Response to reviewers for “Ephemeral stream sensor design using state loggers” by R. Bhamjee and J.B. Lindsay

Figure 1: *Electronic resistance (ER) sensor schematic.*

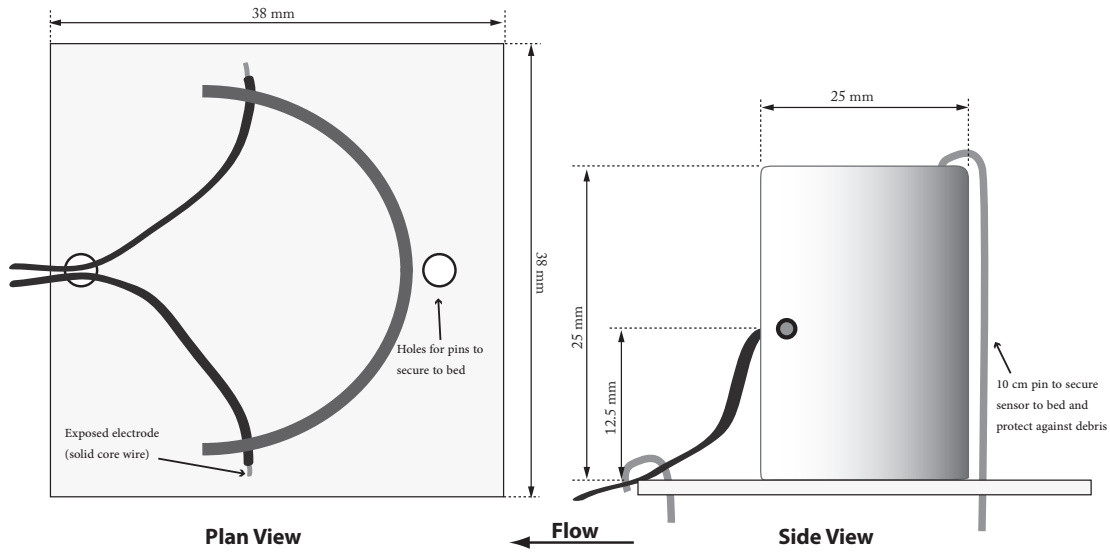
I have rearranged the figure labelling in a way which hopefully makes it easier to read, as well as adding in the missing value of the height of the electrodes and the direction of flow. I will add a colour photo of the sensor set up in a channel as supplemental information with the paper (below).

1. The height has now been specified in Figure 1 (12.5mm). It is correct that flows below this level could be missed, however, there is a tradeoff between the minimal height measurable and the probability of the sensor electrodes being inundated with sediment. Also, having a lower electrode height resulted in higher levels of noise in lab tests due to water pooling on the base of the sensor. Based on the newly added results section where coalescence/disintegration are the dominant expansion/contraction models, it can be assumed that true flow events are not being missed, but rather just the pooling of water.

Figure 2: *Schematic of typical erosional and depositional areas around the sensor head under lab conditions.*

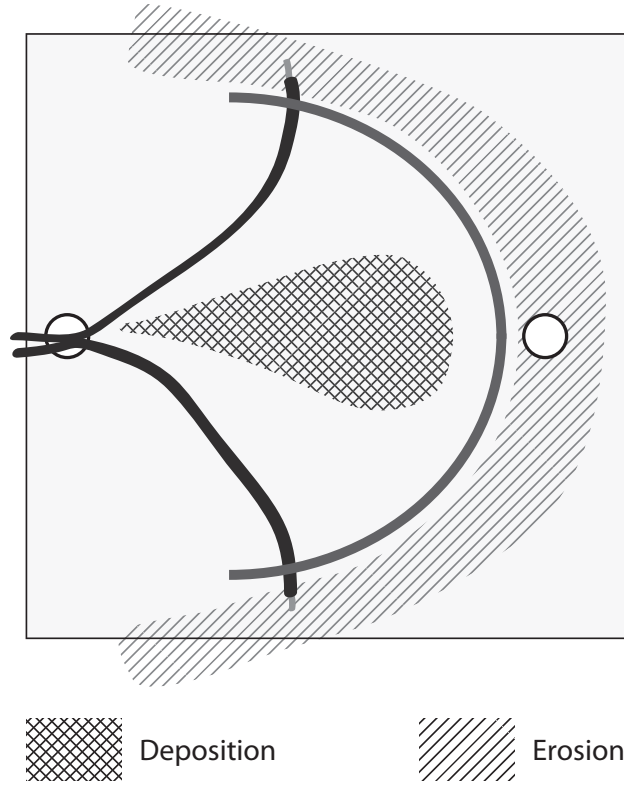
This figure was intended to act as a schematic of the typical erosion/deposition patterns found during the lab testing under direct flow conditions (i.e. not when the sensor was on an angle). I have changed the caption to better reflect that.

7. The schematic was to show the general deposition/scouring around the sensor head under direct flow conditions over the longer tests.

Figure 3: *RARE study sites.*

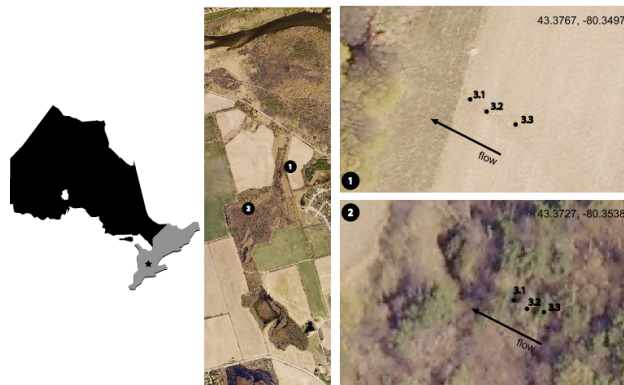
These figures were presented in order to give the reader an idea of the surrounding area of the reaches and where the sensors were set up. I will also include the lat/long coordinates to these to make it easier for the reader to locate them. Arrows have also been added to show downslope direction as per the comment by Reviewer #1.

Figure 5: *Raw data (a) and post-processed data (b) with the noise removed for one sensor head.*

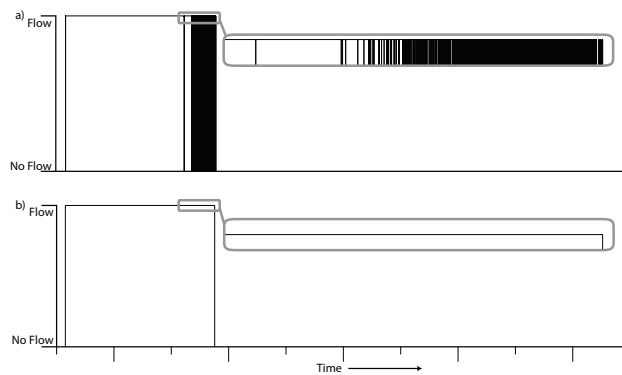
I have altered the figure slightly to clarify what the boxes are showing (i.e. a magnification of the data). I have also labeled the x-axis as time. As an additional note, while the data used in the figure is from the dataset, the figure was being used more as a schematic on the typical noise patterns during onset and cessation of events.

Figure 6: Final flow data from Rondeau Bay study site with noise removed and precipitation intensity.

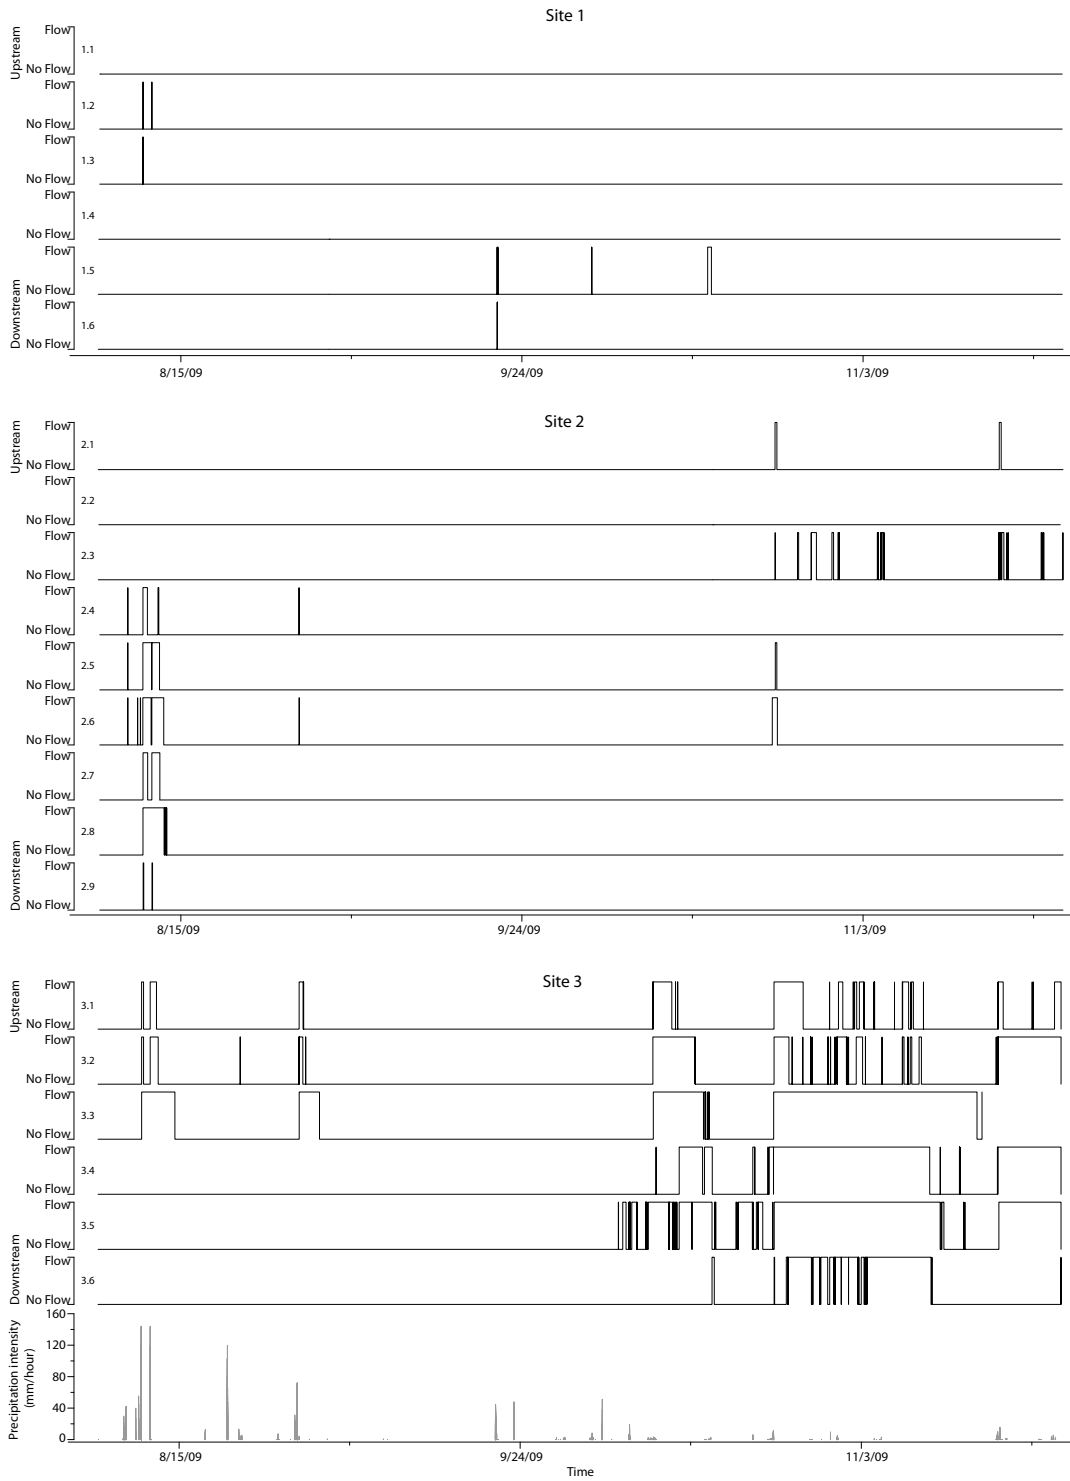
In response to referee #1's comment on providing a figure of both pre-processed and post-processed data for the study site, I have chosen not to do this as the size of the figure limits how much can be seen. Even at the current scale, individual noise events are not clearly visible due to the high temporal resolution (it is evident why when looking at Figure 5). The caption was also altered for clarity.

Figure 7: *Models of stream network expansion. Coalescence: the formation of individual pools which join to create a flowing network; Downstream expansion: movement of water from upstream to downstream; Headward expansion: movement of the channel head upstream.*

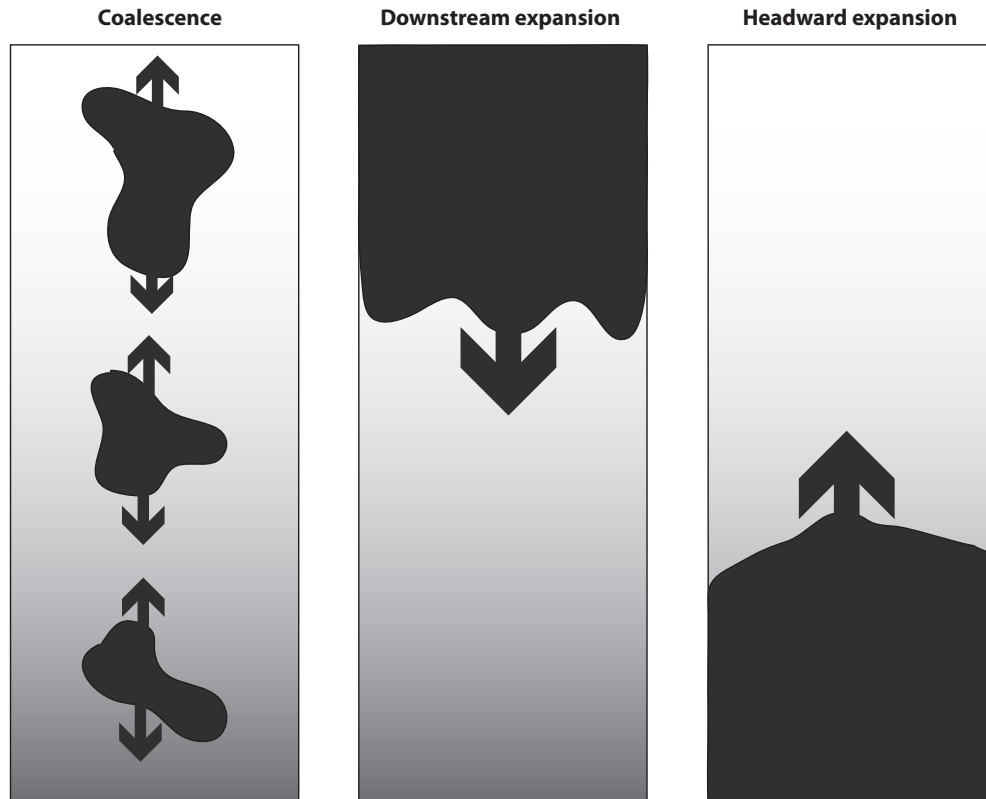
In response to the lack of a results section, one has been added which describes three models of stream network expansion as well as two models of stream network contraction which were observed in the dataset (the addition of two figures which show schematics of these models has also been included). The occurrence of these models (as a percent of all events) in the dataset is also described and presented and two tables have been added which show this information (Tables 1 & 2).
